Product Change Notification / SYST-29COSO613

ERRATA - PIC18(L)F67K40 Family Silicon Errata and Data Sheet Clarification

PIC18(L)F67K40 Family Silicon Errata and Data Sheet Clarification

Figure 38-10: ADC Conversion Timing (ADC Clock F_{OSC}-Based)

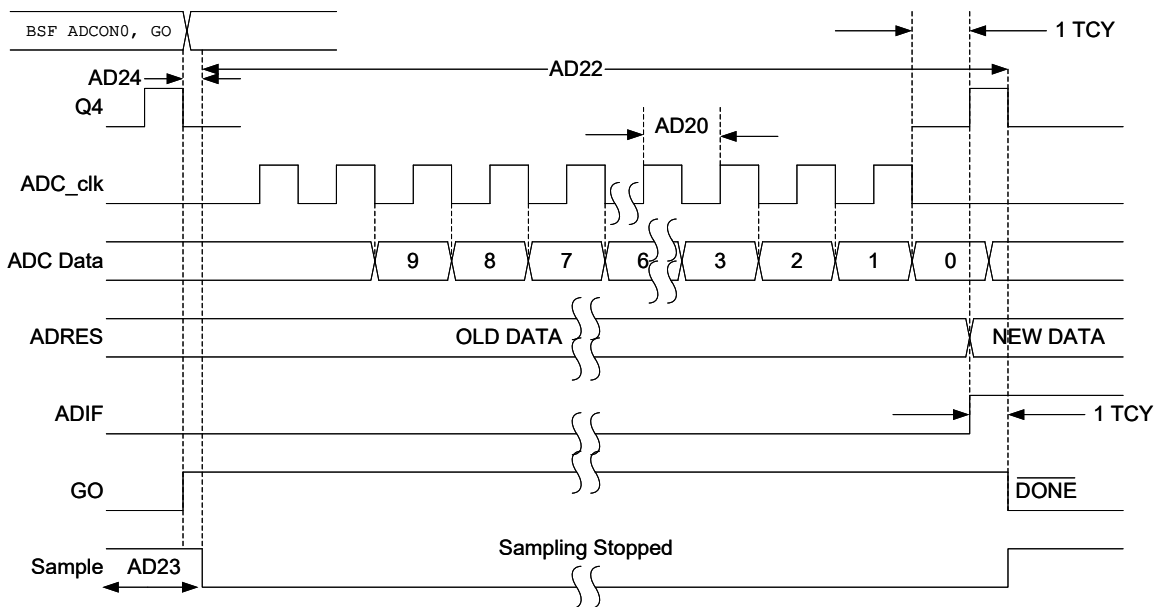
Refer to the images below for corrections of Figure 38-10 and Figure 38-11. Previously, the parameter numbers were incorrect.
